**HARDY COUNTY RURAL DEVELOPMENT AUTHORITY
HARDY COUNTY, WEST VIRGINIA**

AMERICAN WOODMARK INDUSTRIAL ACCESS ROAD

ADDENDUM #1

THRASHER PROJECT #030-2970

SHEET No.
18.1

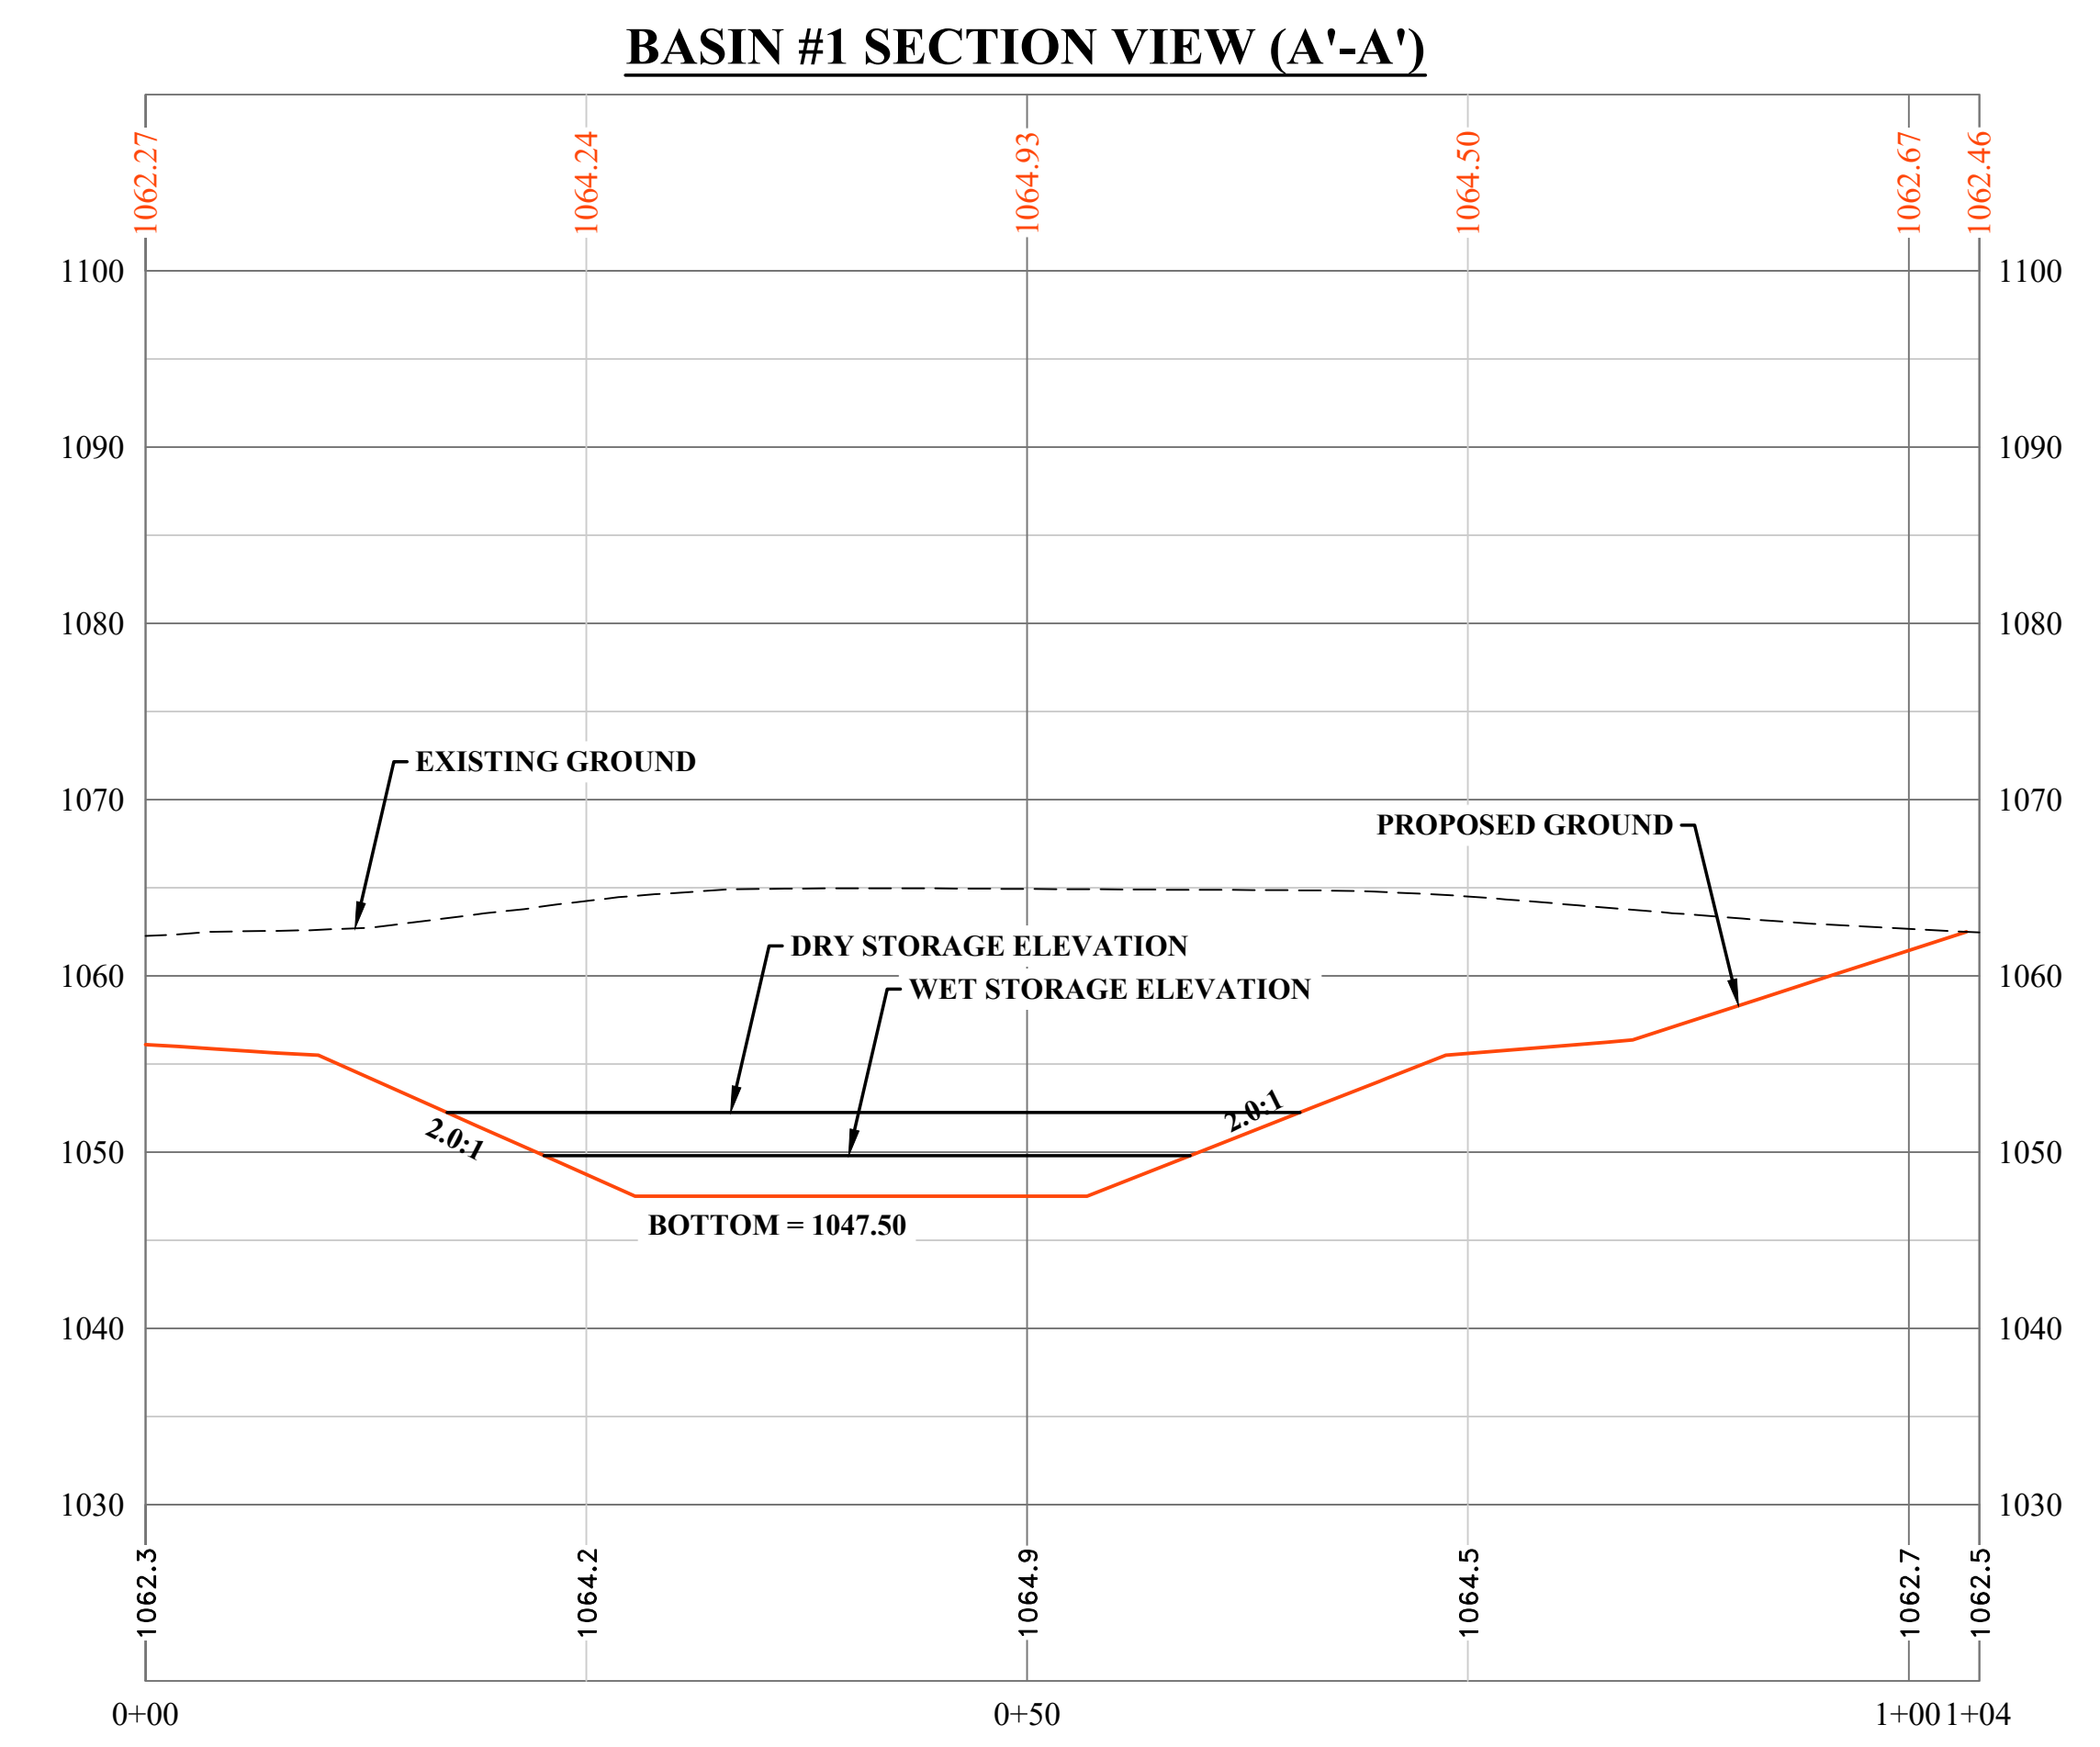
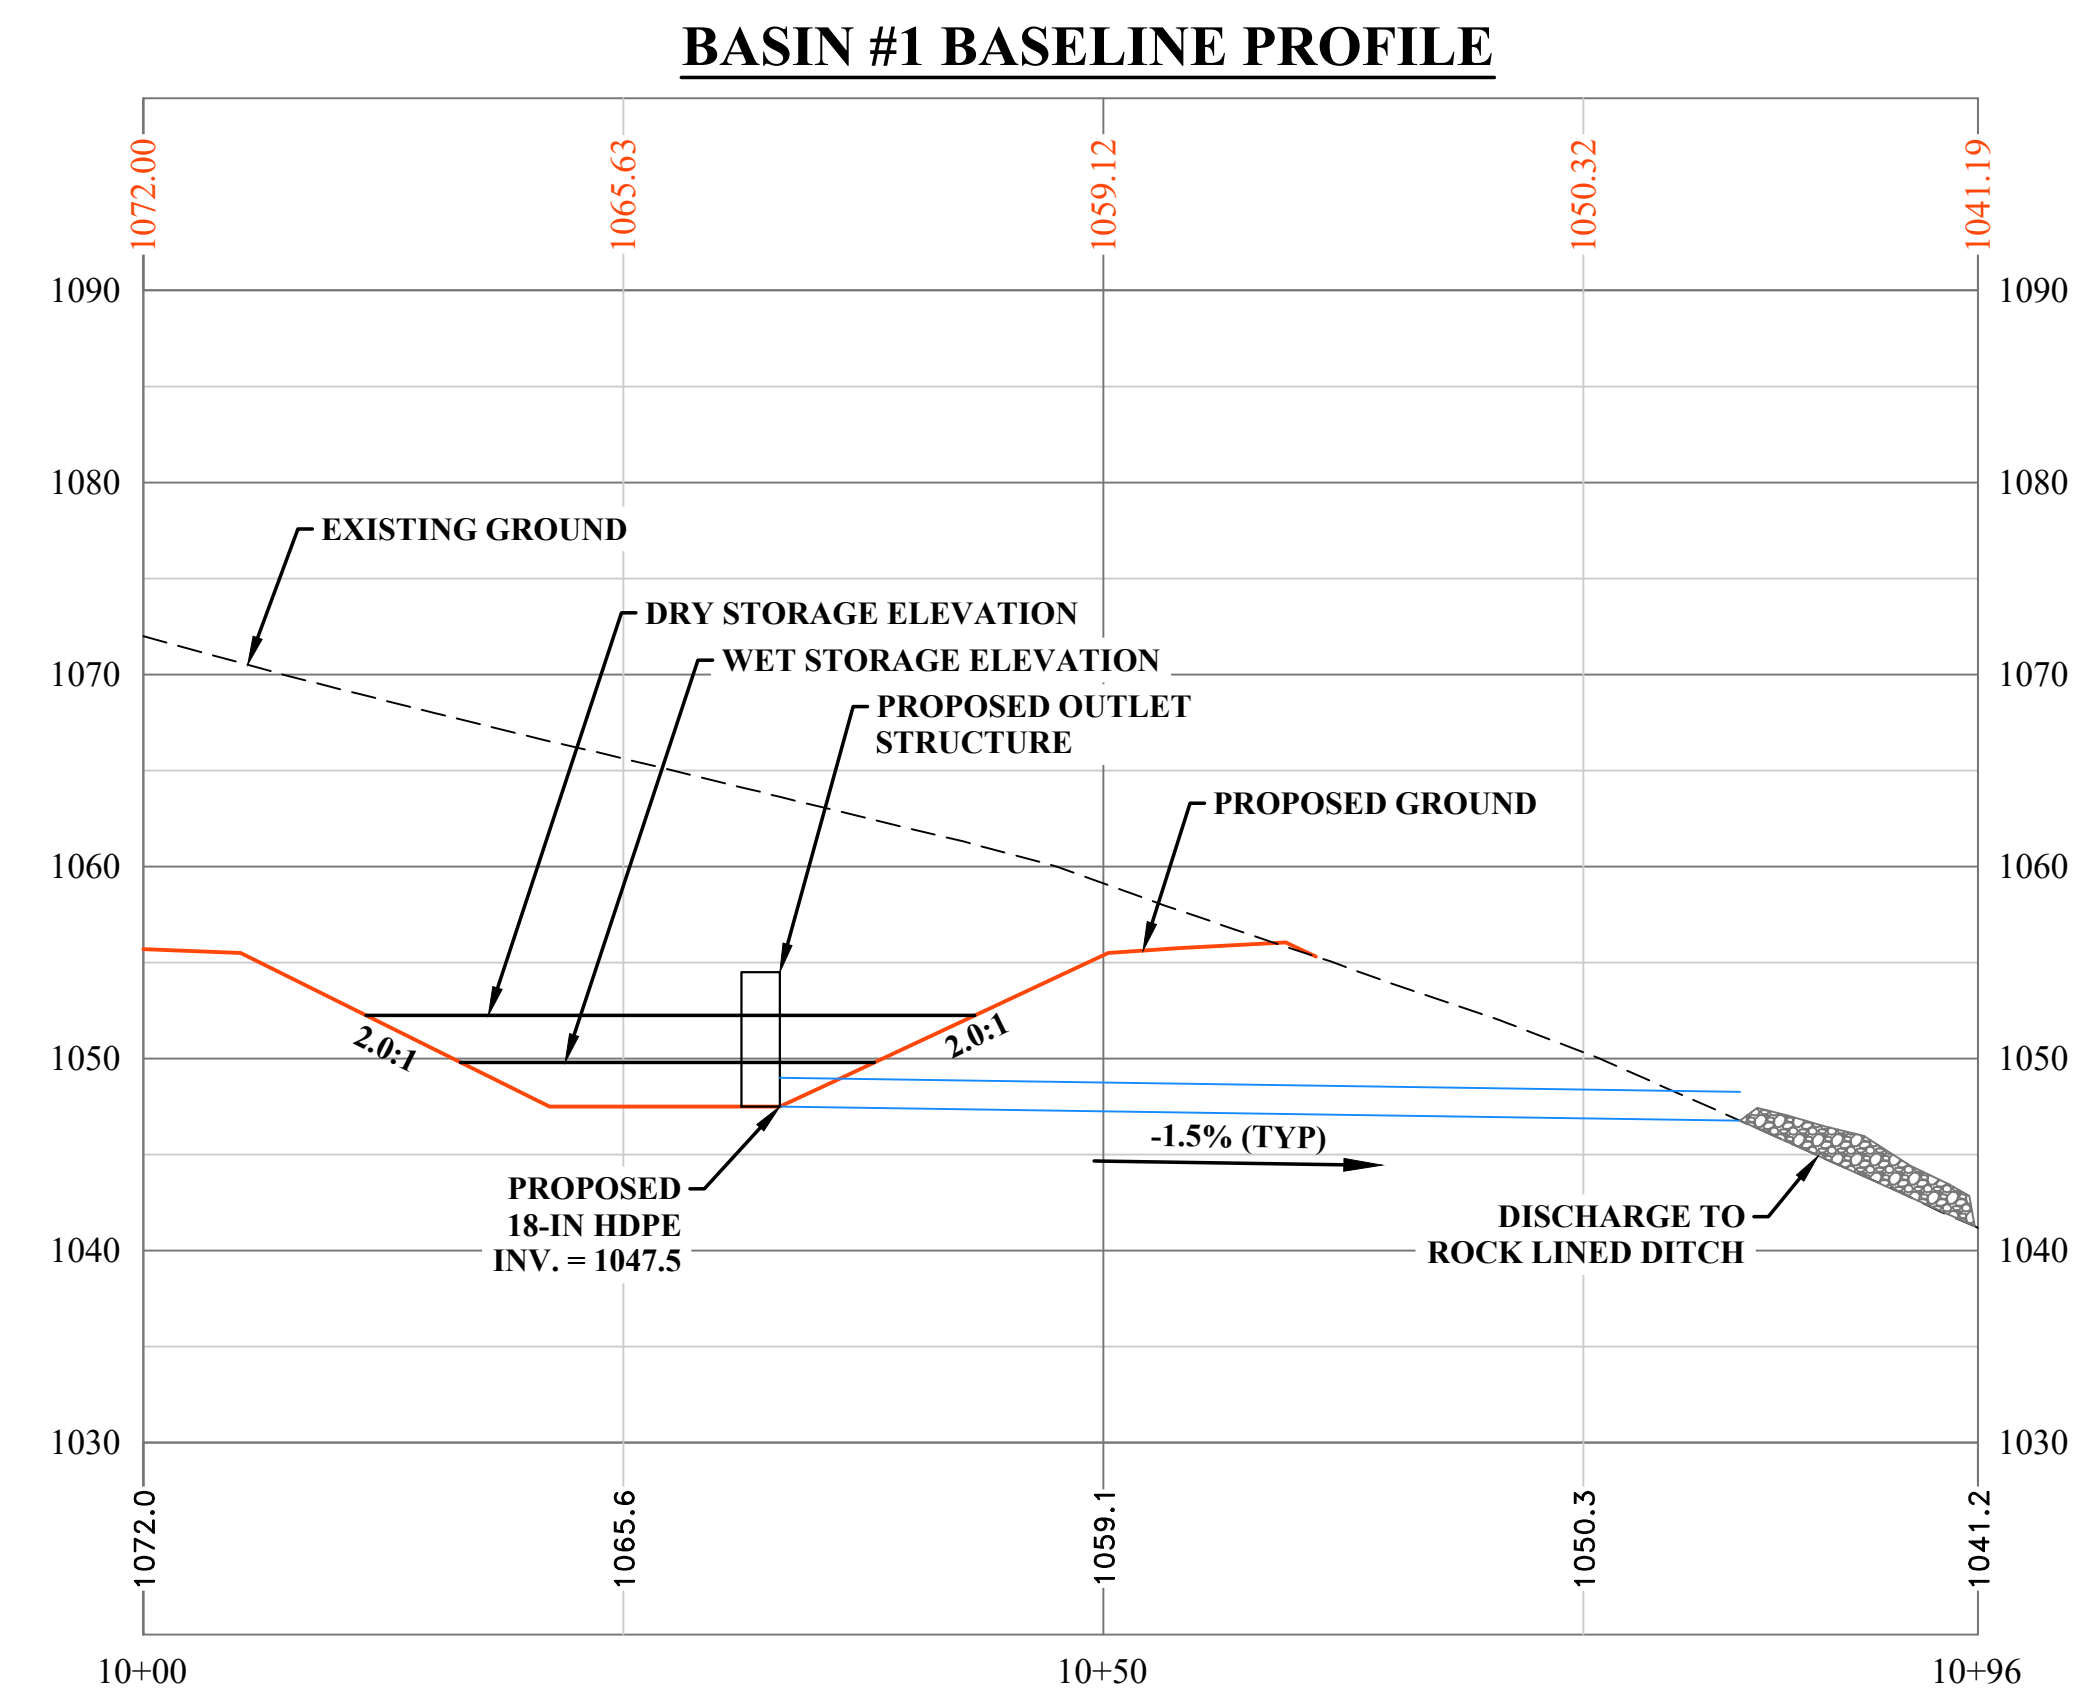
Can you provide a detail for the basin in the borrow area with outlet details?

Can you provide additional information for proposed basin #1? I do not see any specification for the outlet structure, outlet pipe, or spillway.

Plan Sheet 18.1 was added to the plans to provide the basin details.

Plan Sheet 18.1 was added to the plans to provide the basin details.

NO.	BY	DATE	DESCRIPTION
1	REM	10.13.2022	ADDENDUM 1 - ADDED STORM BASIN DETAIL
